MEMORANDUM

TO: District of Columbia Board of Zoning Adjustment
FROM: Arthur Jackson, Case Manager
 Joel Lawson, Associate Director Development Review
DATE: September 13, 2011
SUBJECT: BZA Case No. 18248, 1427 Rhode Island Avenue NW

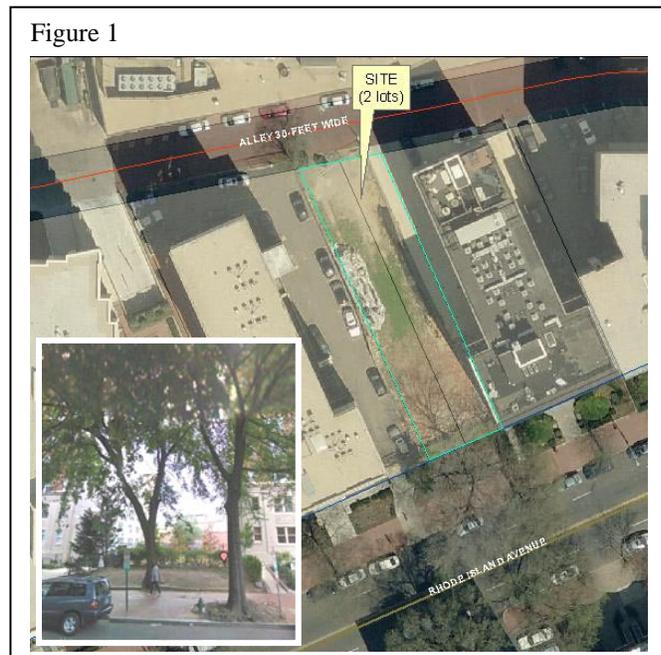
At 40 x 159 feet the project site is extremely long relative to its width. The combined land area of 6,181 square feet still makes it one of the smallest sites on this frontage of the square. Current regulations would require a 14-foot wide drive aisle for two-way traffic to serve one perpendicular row of 9 x 19-foot parking spaces (to site is not wide enough for two rows of parking). Even if parking occupied the entire area below grade, only nine 9 x 19-foot parking spaces could be accommodated south of driveway ramp. A multi-level underground garage is not an option due to property size and the associated construction cost.

The site width and size, therefore, present a practical difficulty to providing the required number of parking spaces onsite. In order to increase the onsite parking available the applicant proposed to provide smaller 9 x 16- and 9 x 17-foot spaces, which would be larger than the compact car standard of 8 x 16-feet, and use a tandem configuration. While not enough to meet the requirement, this alternative parking strategy would provide more spaces than could be accommodated onsite under the currently regulations.
